PIC18F87J11 Family Silicon Errata and Data Sheet Clarification

The PIC18F87J11 family devices that you have received conform functionally to the current Device Data Sheet (DS39778D), except for the anomalies described in this document.

The following typographic corrections and clarifications are to be noted for the latest version of the device data sheet (DS39778D):

FIGURE 19-10: I²C™ SLAVE MODE TIMING (TRANSMISSION, 7-BIT ADDRESS)

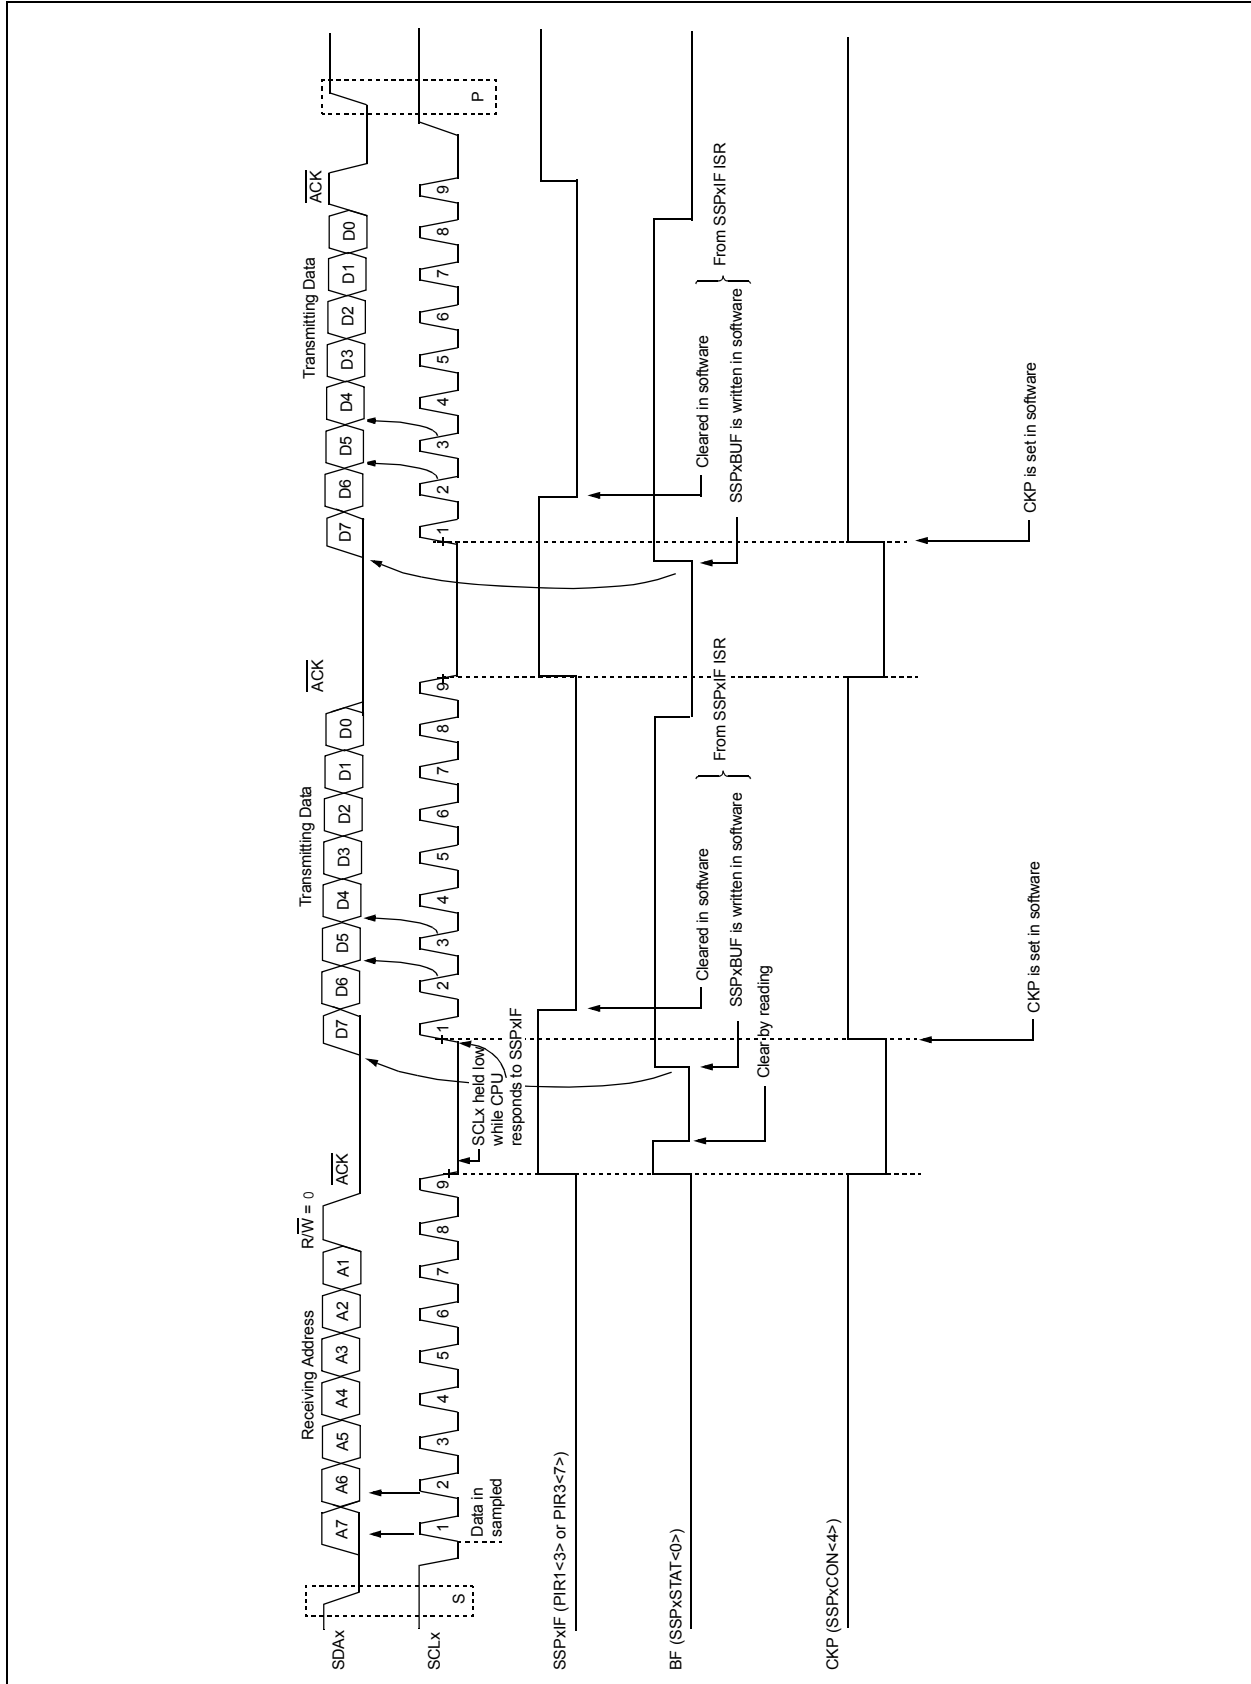
7. Module: Figure 19-10: I²C™ Slave Mode Timing (Transmission, 7-Bit Address)

On page 244, the figure is replaced with the new timing diagram provided in Figure 19-10.

FIGURE 5-7: DATA MEMORY MAP FOR PIC18F87J11 FAMILY DEVICES

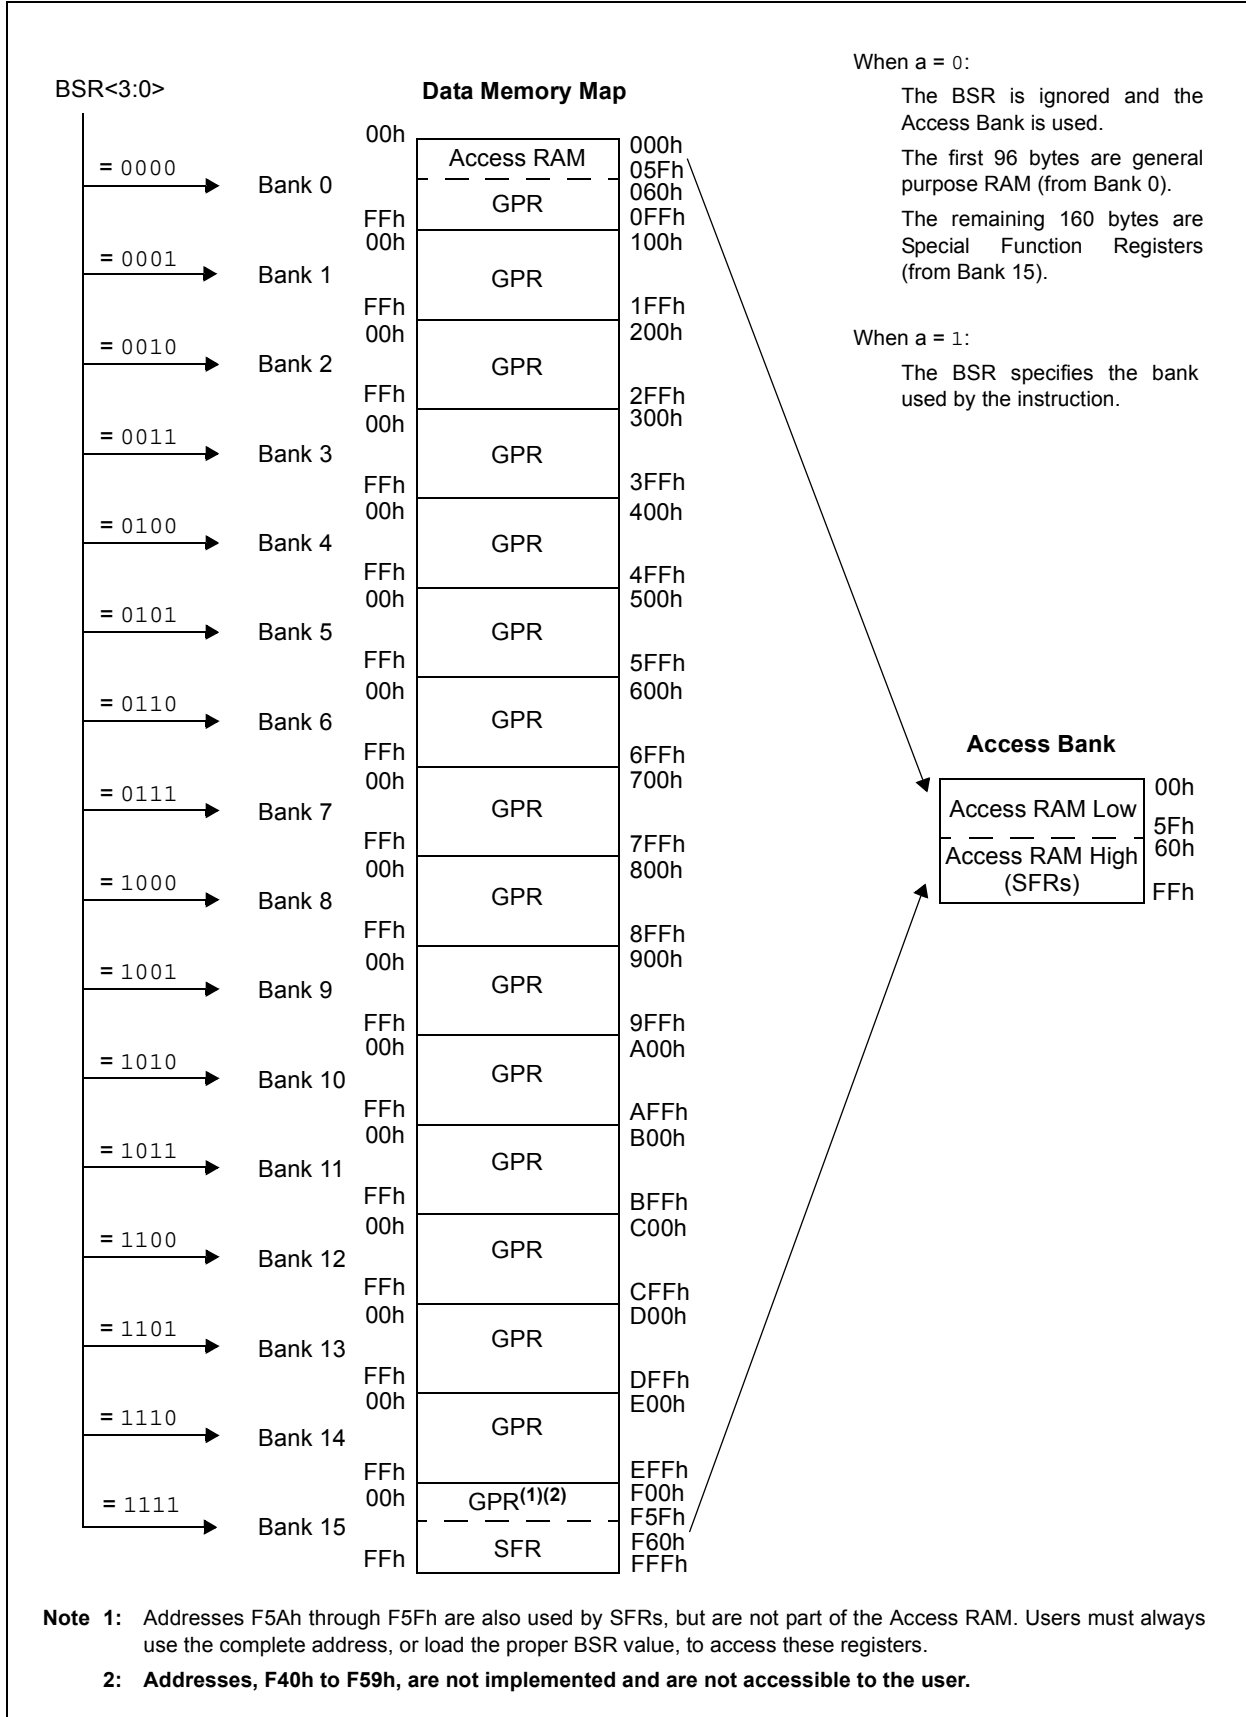
11. Module: Memory Organization

On page 73, in Figure 5-7, Note 2 has been added. The additional note is indicated in bold text in Figure 5-7.
